The Eastern Corridor

MEETING #4 NOTES

Eastern Corridor Segments II and III

US 50 Corridor Focus Area

Right Turn Lane Extension By Parking Restriction at Watterson and US 50 Intersection

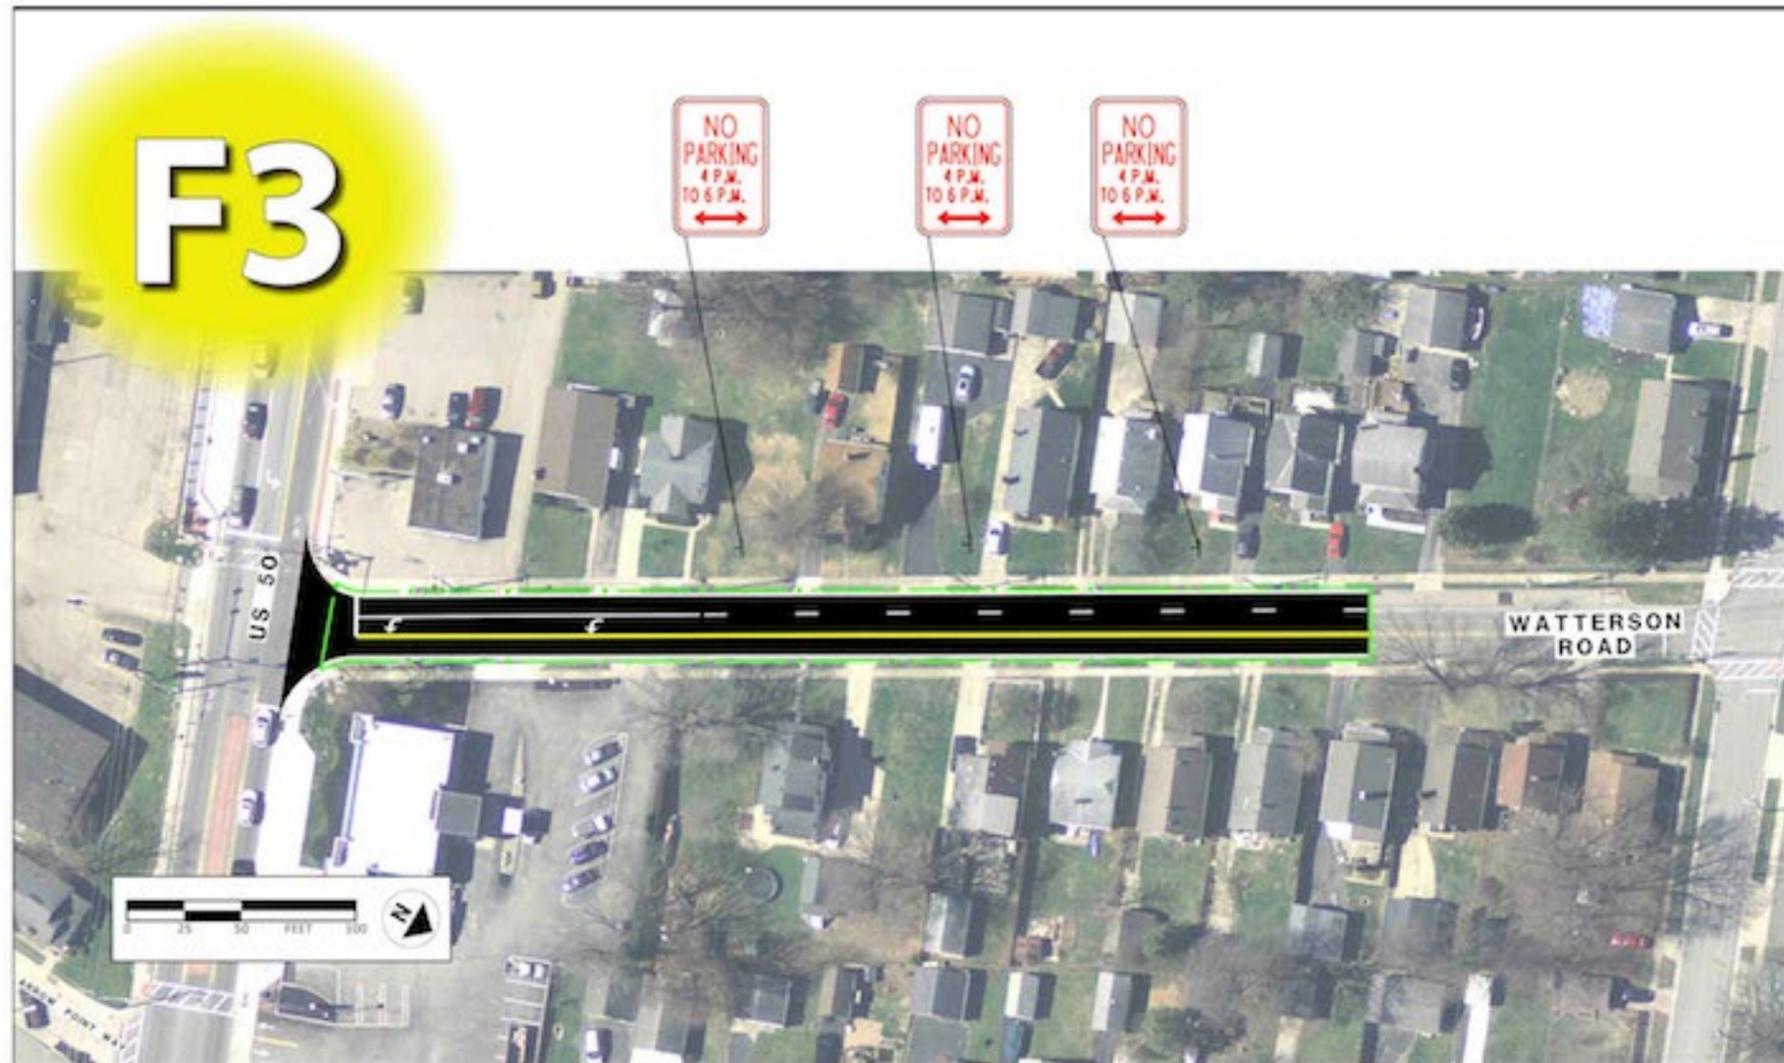
- This concept is designed to address delays for drivers turning from Watterson Road onto US 50.
- The result would stripe a lane for drivers turning left from Watterson Road onto US 50 (Wooster Pike). Currently, the queue for drivers turning left blocks those turning right, although the number of left turns is significantly higher in both morning and evening peak hours (AM = 70 right turns, 130 left turns; PM = 80 right turns, 280 left turns).
- Peak hours are between 7 a.m. and 9 a.m., and 4 p.m. to 6 p.m.
- The loss of parking for homeowners living on the street would need to be weighed against any potential traffic benefit.

- Further study indicated that this concept shows little improvement (6 percent) during AM peak hours (when there is minimal traffic); during PM peak hours however, it resulted in a 31 percent reduction in traffic delays compared to the No Build option.
- This concept would be implemented through new pavement markings and added signage.
- If implemented, the parking restrictions would be inconvenient to Watterson residents.

- Several residents on Watterson reported backups on Watterson due to traffic signal timing changes. ODOT noted that this is understandable because signal adjustments made to help traffic on US 50 flow better would result in longer turning delays on Watterson.
- The committee agreed that this concept should be designated as a low priority.
- ODOT noted that if desired, restriping on Watterson can be completed as part of its upcoming resurfacing project (PID 101309) to be completed in 2019. Fairfax noted that if a decision to advance the project is made after ODOT's project is complete, Fairfax would likely be able to complete the project using Village resources.

- Include project in Implementation Plan as a low priority. It will be up to the Village of Fairfax to advance this project if they think it will improve traffic flow.

Maintain Parking Along Inside Edge of Square

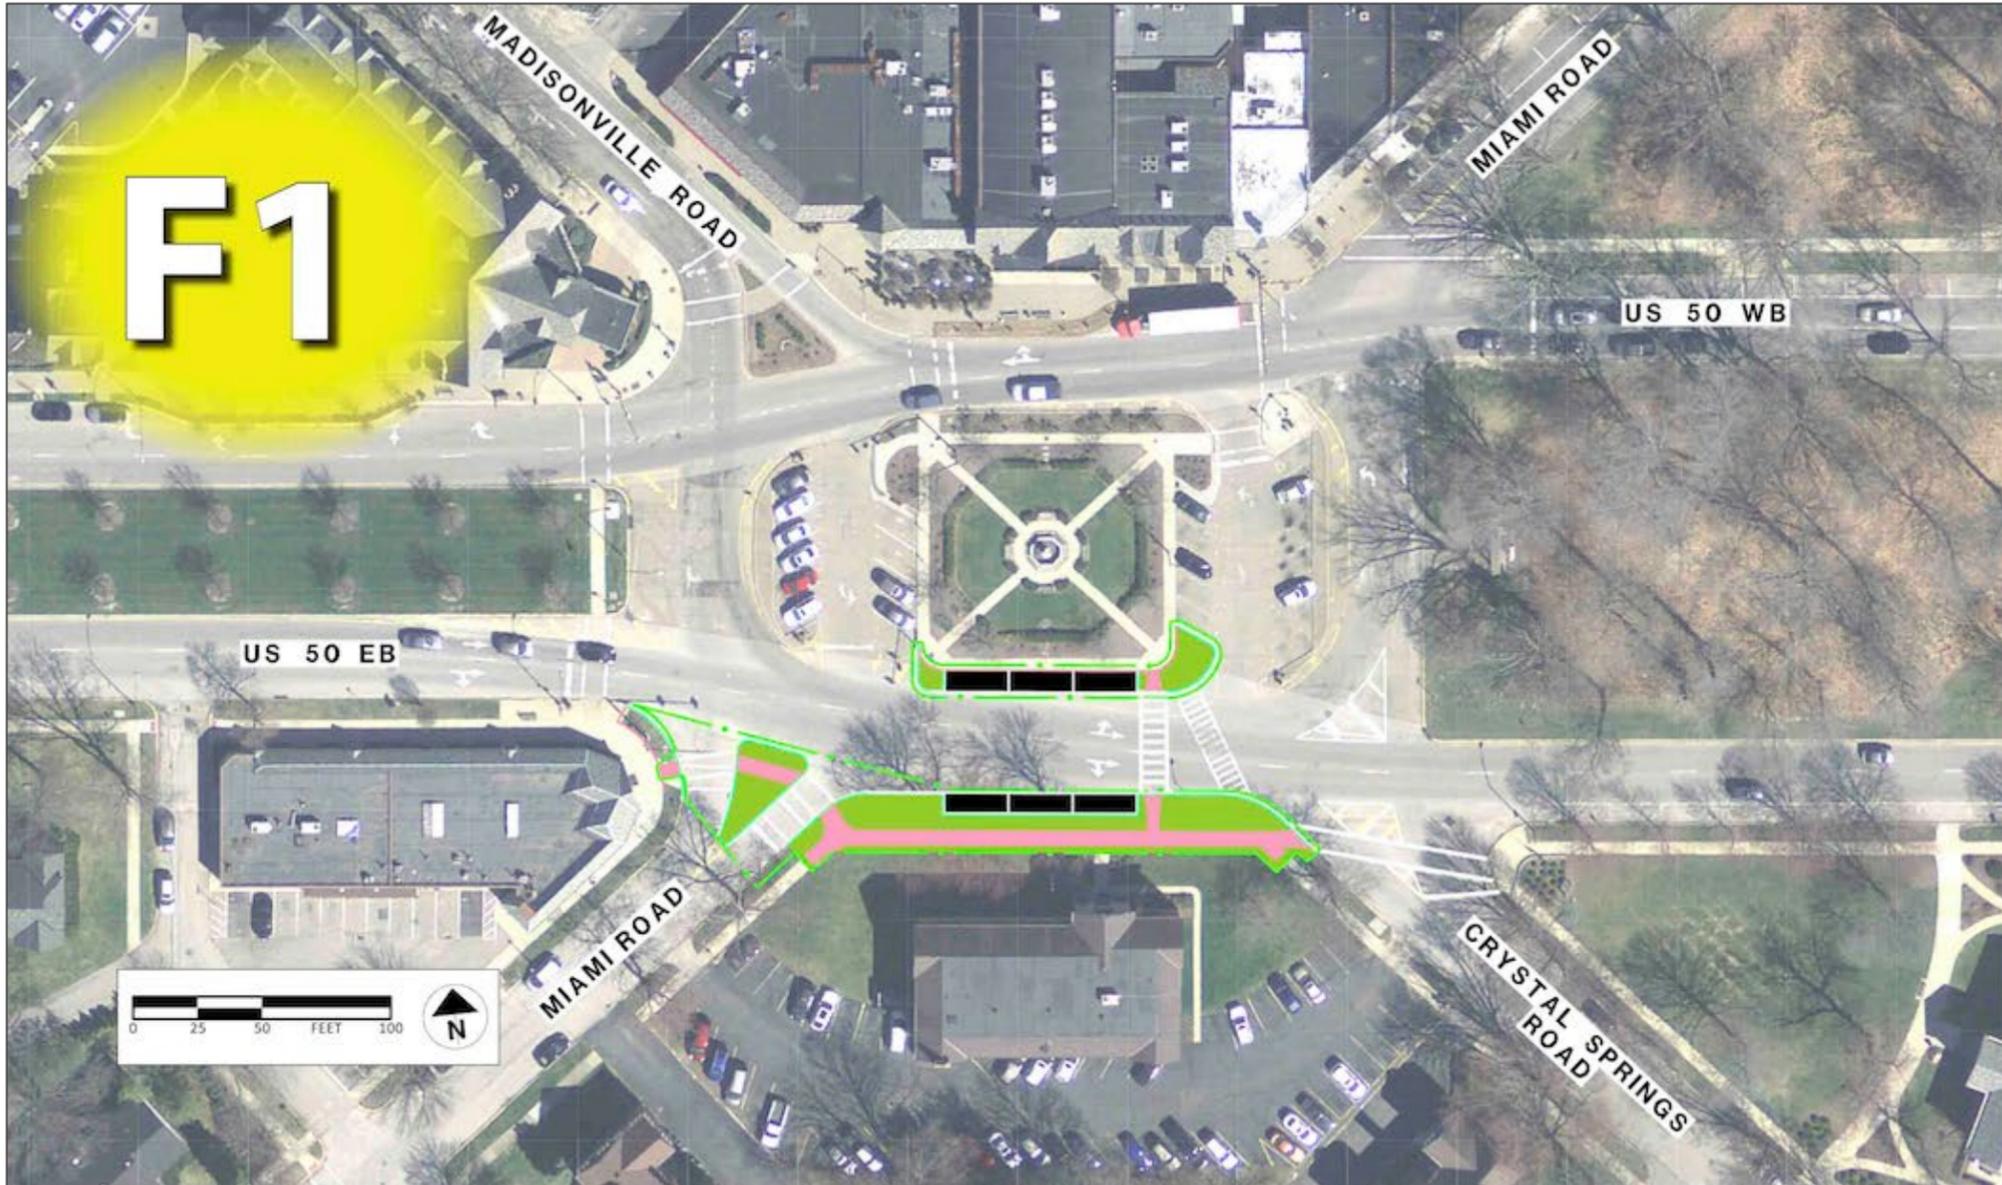
- This concept is intended to address a sight deficiency for drivers traveling northbound on Miami Road and turning right onto Wooster/US 50 (south side of Mariemont Square). This movement is currently not signalized.
- A curb bump would be added, moving the stop bar (line in the road) forward so that drivers are better able to see past the existing building on their right.
- The concept has the additional potential benefit of straightening the existing crosswalk. This would be particularly helpful for pedestrians.
- The four existing parking spaces would be preserved.
- Pavement removed in this concept could be replaced with grass. Existing trees would be saved.
- A new raised island could be established on Miami Road, similar to the island on Plainfield Road on the north side of the Square

- The only difference between this option and Concept I-13e is whether to retain the three, parallel parking spaces along the south side of the center island in Mariemont Square. In this alternative, the parking spaces are retained.
 - There are aesthetic benefits to removing the parking spaces; however, they are often used by patrons of businesses in Mariemont Square.
- One parking space would be removed on the south side of the US 50/Wooster Pike in the Square, in front of the businesses. Removal of this space improves sight lines for vehicles on Crystal Springs Road and therefore improves travel safety.

- The Advisory Committee noted that feedback from the public was generally neutral to favorable, however, some people did not like or opposed the project (see Public Feedback Ratings Summary, next page).
- Concept I-13e (F2) is similar to concept I-13d (F1); the primary difference between the two is that the three parallel parking spaces located along the south side of the center island would be kept with I-13d (F1) but removed with Concept I-13e (F2).
- It will be up to the Village of Mariemont to ultimately choose between concepts I-13d and I-13e. At this time, feedback received from the public indicates a slight preference for concept I-13d (F1), which retains the parking spaces.

- Include project in Implementation Plan as a low priority. It will be up to the Village of Mariemont to choose between concepts I-13d (F1) and I-13e (F2) and decide whether or not to implement the project.
- Consider advancing the sidewalk relocation component as a separate, higher priority project.

Remove Parking Along Inside Edge of Square

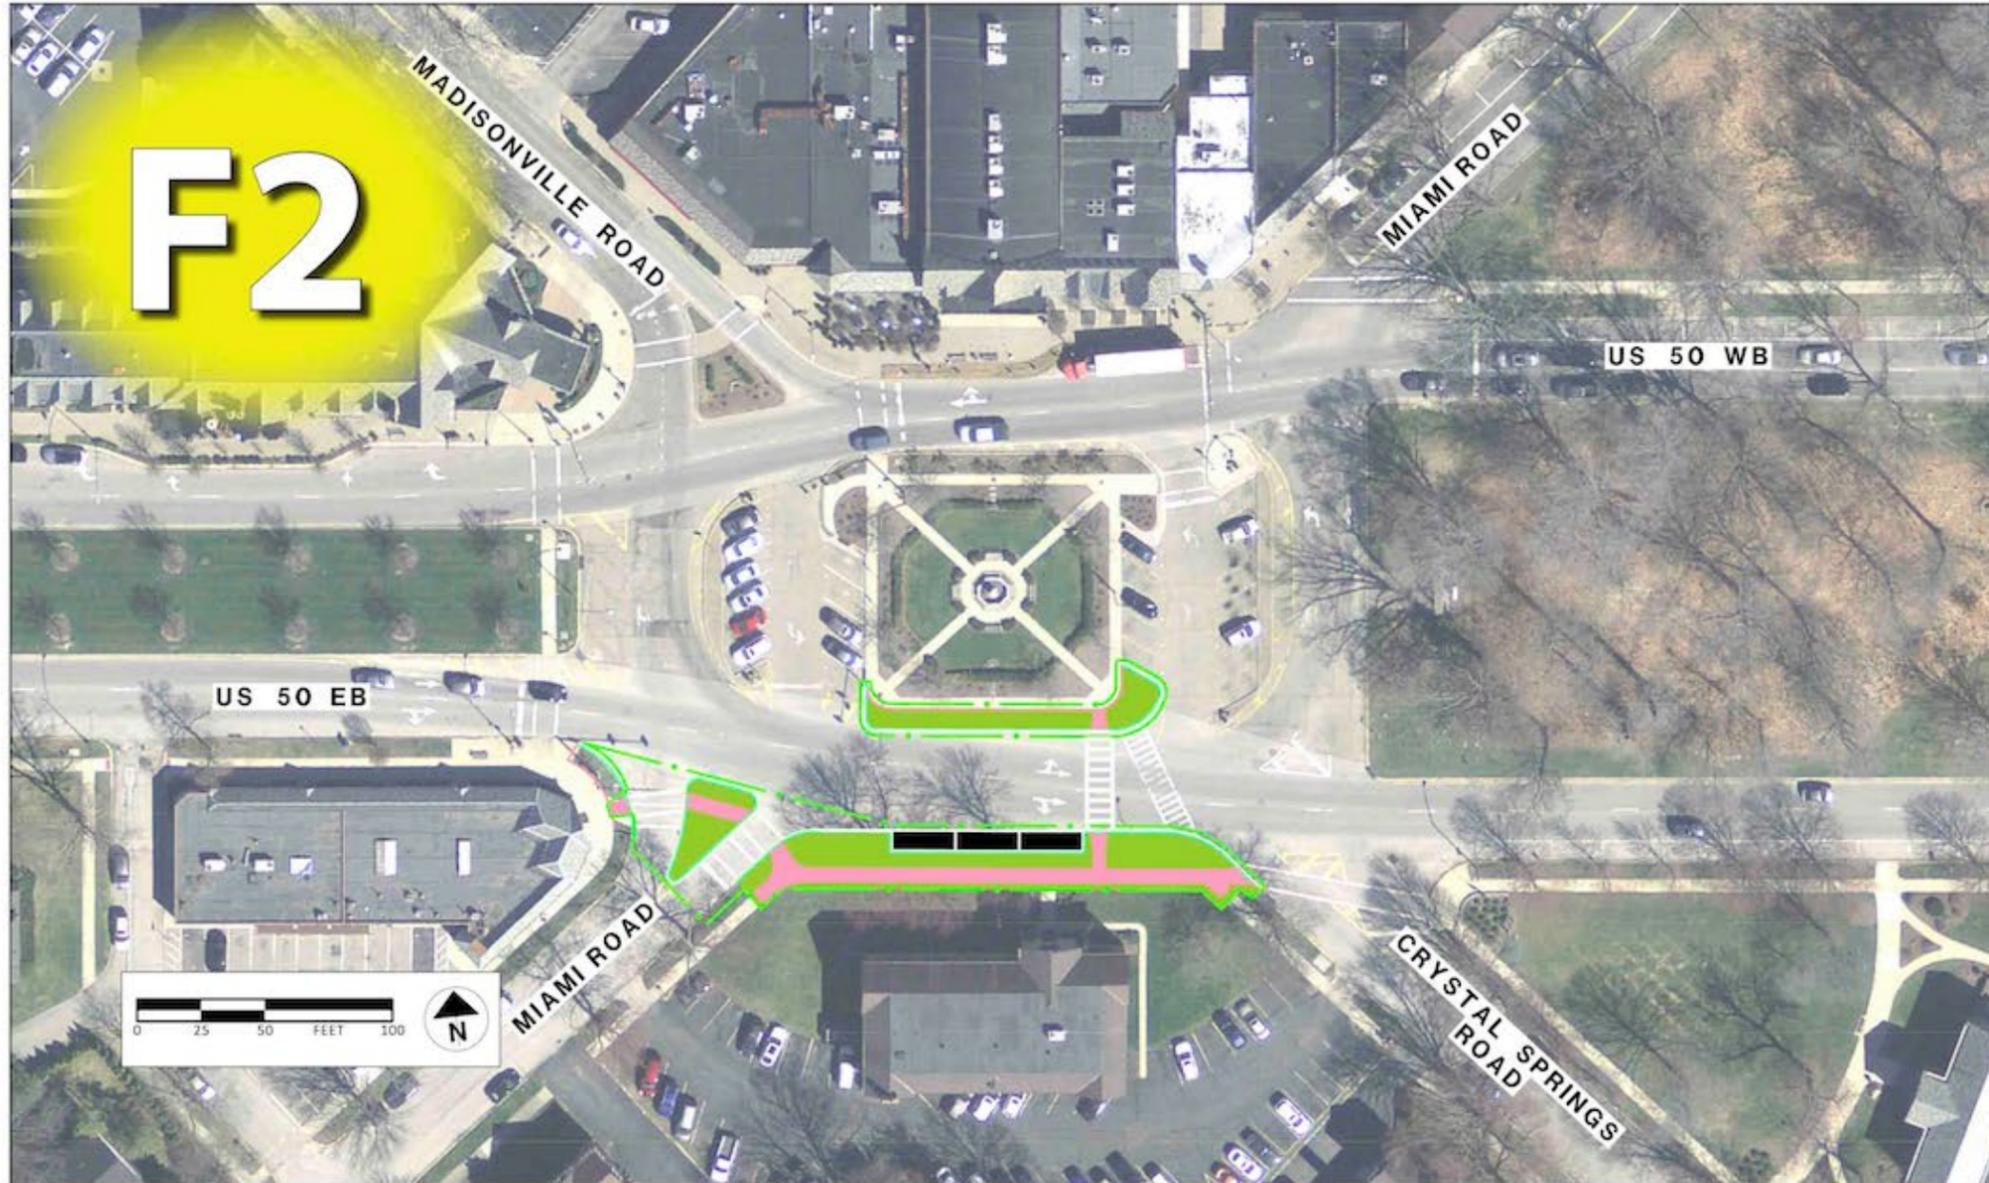
- This concept is intended to shorten the length of the crosswalk across US 50 at Crystal Springs Road at the southeast corner of the Square.
- Bump outs on both sides of US 50 would not impede traffic lanes but would shorten the amount of time pedestrians spend in an uncontrolled crossing.
- The two eastern-most parking spots on the south side of the Square would be removed to improve sight distance.
- This concept could be implemented in conjunction with I-13d.
- The committee suggested the following:
 - Consider adding a straight crosswalk on the southeast corner of the Square to connect the two shortest points.
 - Consider installing blinking lights on crosswalks to help improve their visibility (ODOT noted that Mariemont would need to fund the addition of blinking lights)

- The only difference between this option and Concept I-13d is whether to retain the three, parallel parking spaces along the south side of the center island in Mariemont Square. In this alternative, the parking spaces are removed.
 - There are aesthetic benefits to removing the parking spaces; however, they are often used by patrons of businesses in Mariemont Square.
- One parking space would be removed on the south side of the US 50/Wooster Pike in the Square, in front of the businesses. Removal of this space improves sight lines for vehicles on Crystal Springs Road and therefore improves travel safety.

- The Advisory Committee noted that although more than 70% of respondents said they were either neutral, liked or strongly supported concept I-13e (F2), more respondents disliked or strongly opposed it as compared to those disliking or opposing concept I-13d (F1). See Public Feedback Ratings Summary, next page.
- Concept I-13e (F2) is similar to concept I-13d (F1); the primary difference between the two is that the three parallel parking spaces located along the south side of the center island would be kept with I-13d (F1) but removed with Concept I-13e (F2).
- It will be up to the Village of Mariemont to ultimately choose between concepts I-13d and I-13e. At this time, feedback received from the public indicates a slight preference for concept I-13d (F1), which retains the parking spaces.

- Include project in Implementation Plan as a low priority. It will be up to the Village of Mariemont to choose between concepts I-13d (F1) and I-13e (F2) and decide whether or not to implement the project.
- Consider advancing the sidewalk relocation component as a separate, higher priority project.

Maintain Two Lanes in Each Direction on US 50 at Chicane

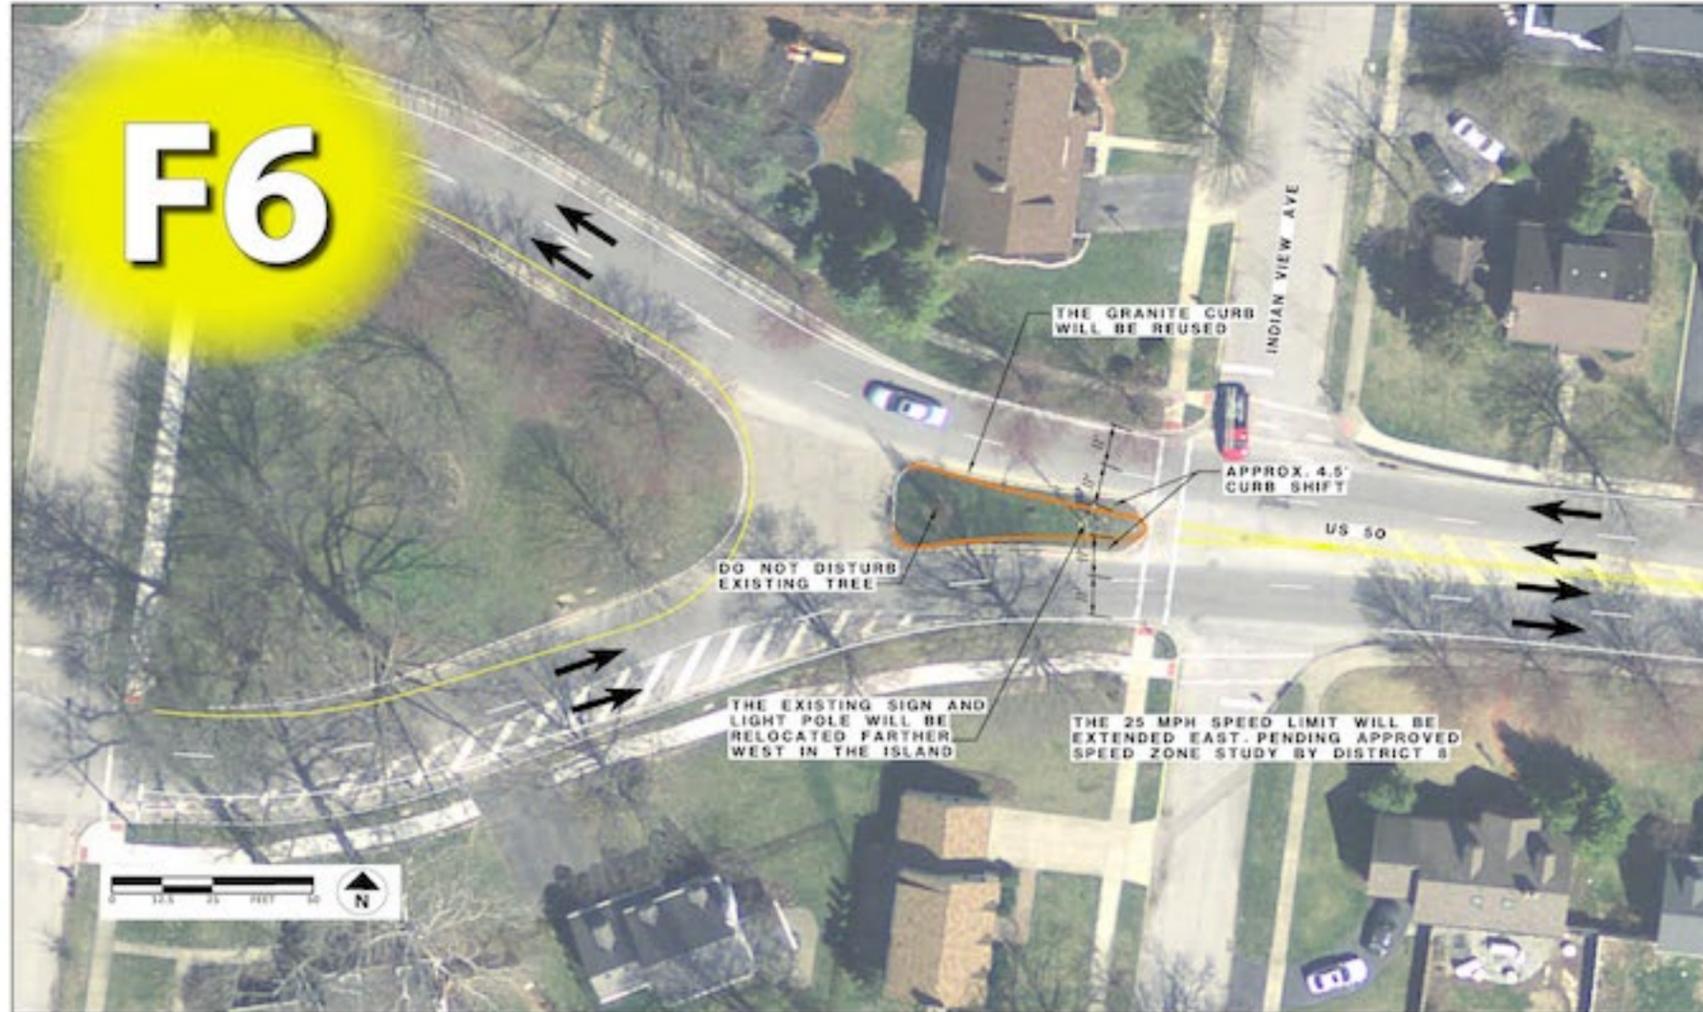
- The Committee addressed the issue of eastbound afternoon peak hour delays. One potential issue is that traffic currently experiences a pinch point on US 50 between East Street and Petoskey Avenue because it is forced from two lanes to one and then back to two lanes. It may be possible to carry two lanes through with restriping and minor widening.
- At one point, the section was restriped to one through lane, with a left turn lane at Pocahontas for a very brief period of time. This caused a significant backup and was removed.
- Simulations will show whether two lanes could make a difference in addressing delays.

- People aware of the existing travel pattern in this area begin merging as far back as the Pocahontas Avenue signal, resulting in delays at Pocahontas and US 50 and inefficient lane utilization from this intersection through the Square.
- A minimal amount of space from each side of the traffic island (one foot, either side) would be needed to implement this change; work can be done in conjunction with PID 101309 to be completed in 2019.
- New pavement would be added by narrowing the island by 1 foot on each side and restriping the existing lanes.
- The concept would require reducing speed in this area from 35 to 25 miles per hour.

- This concept has potential to provide traffic calming and lane utilization benefits farther east, as currently there is poor lane utilization extending back to Pocahontas Ave. Therefore, it has been retained for further consideration.

- To allow enough space for a continuous second lane, the east end of the the traffic island located immediately east of Indian View Avenue would need to be trimmed on its sides by approximately 4 ½ ft. This small modification would only be made to the sides of the island.

- The Advisory Committee discussed reducing the travel speed within the area from 35 mph to 25 mph. As part of its evaluation of this concept, ODOT completed a speed study for this area; results indicate that it makes sense to consider reducing the travel speed to 25 mph. This change would especially be beneficial if the travel lanes between East Street and Petosky Avenue are increased from one to two (the curves in this area would be designed for a travel speed of 30 mph).

- Reasons respondents gave for disliking or opposing this concept included concerns that vehicles would travel faster through the area if an additional travel lane is added, and, the change would impact John Nolen’s original design for the community at this location.

- ODOT’s Office of Environmental Services (OES) would like to review this project with the Village of Mariemont in more detail; the State Historic Preservation Office did not express any specific concerns.

- This project is on hold because the Mariemont Planning Commission voted to not approve the proposed change in January 2019.

POST MEETING NOTE: The Mariemont Planning Commission voted in January 2019 to not approve the proposed change. Therefore, the lane modification will not be taking place in conjunction with the proposed resurfacing work (PID 101309) in 2019.
